project	RESIDENTIAL DEVELOPMENT SITE AT HERITAGE GATE COED DARCY PHASE 2
client	JEHU
drawing

HOUSETYPE W1B
PLANS & ELEVATIONS
EXISTING AND PROPOSED

project	drg no.	rev.
9117	PH2-S73-PL13	A

SIDE ELEVATION 1 (EXPOSED)

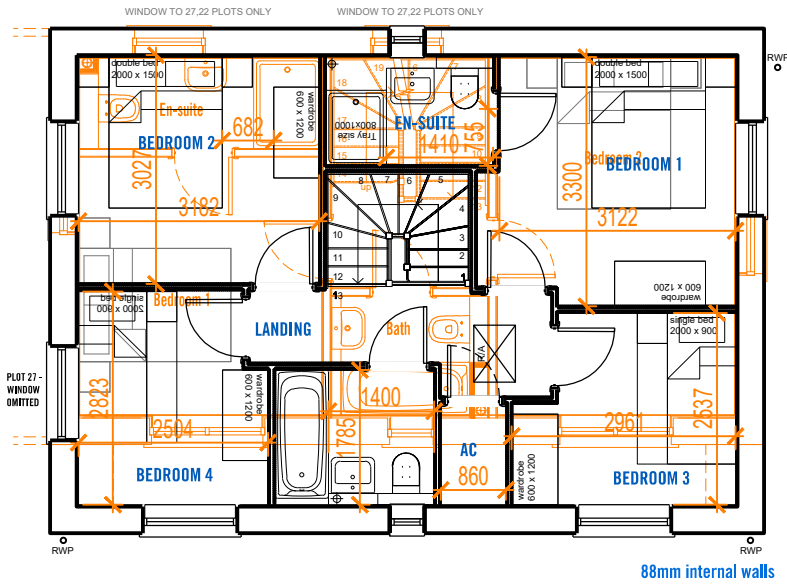
rev.	date	description
A	14.08.20	Updated to LPA's comments: - Plot 27 - two windows removed (side elevation) ;
